TECHNICAL SERVICE BULLETIN

SUBJECT:		No: TSB-08-42A-008	
CORRECTED PROCEDURES FOR DTCS B240A & B240B - SERVICE MANUAL REVISION		DATE: May, 2008	
		MODEL: See Below	
CIRCULATE TO:	☐ GENERAL MANAGER	☐ PARTS MANAGER	☒ TECHNICIAN
☒ SERVICE ADVISOR	☒ SERVICE MANAGER	☐ WARRANTY PROCESSOR	☐ SALES MANAGER
TSB Revision: TSB-08-42A-008

The descriptions for DTCs B240A and B240B are incorrect in the applicable Service Manuals. This Technical Service Bulletin provides the corrected information. Apply the listed attachment to the related service manual page from the Applicable Manuals listing below.

Outside Transmission Antenna assembly (Driver's Side) Circuit

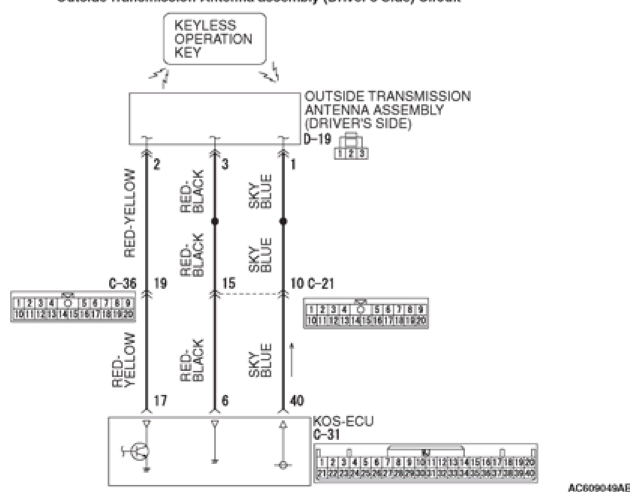
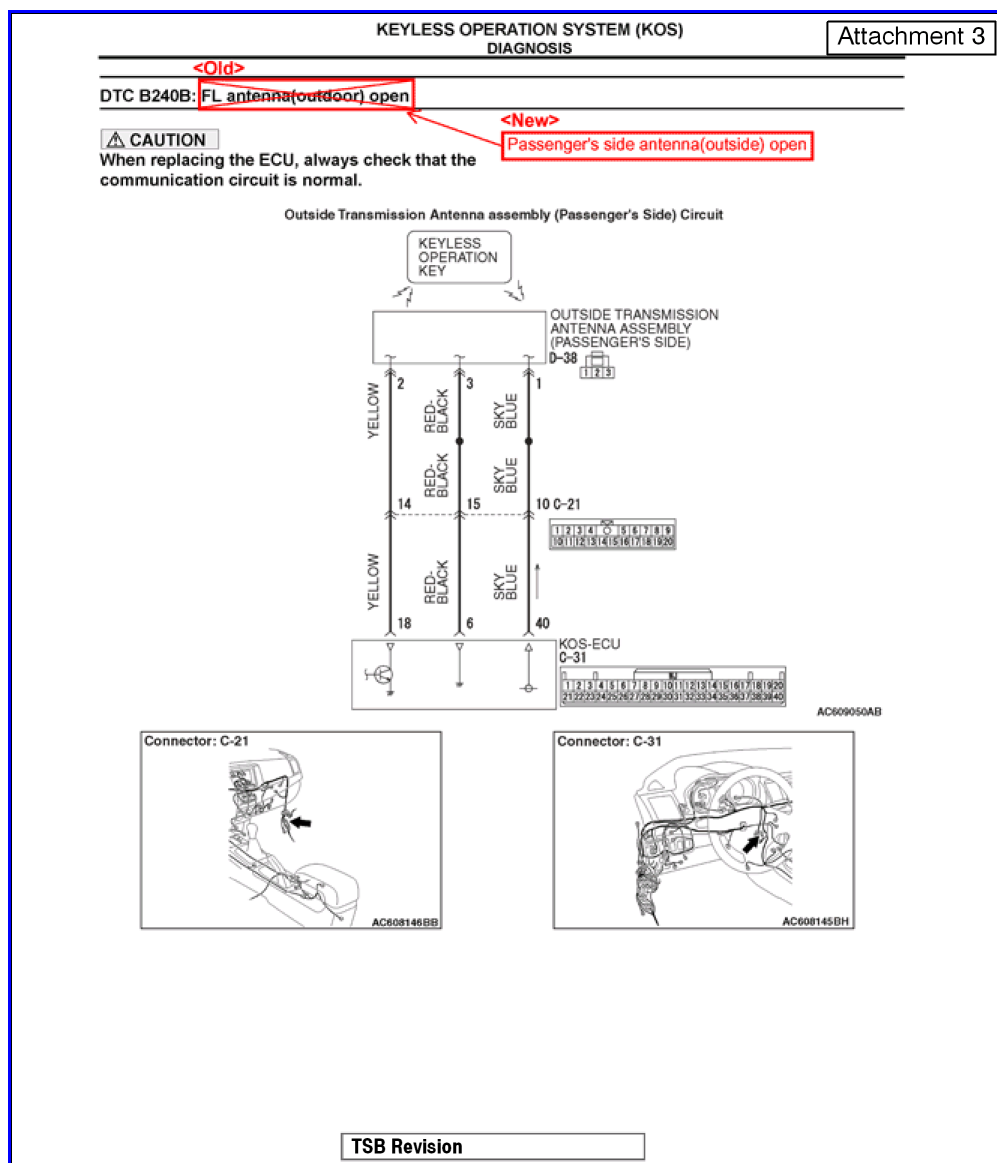
<New>

Driver's side antenna(outside) open

<Old>

DTC B240A: ~~FR antenna(outdoor) open~~
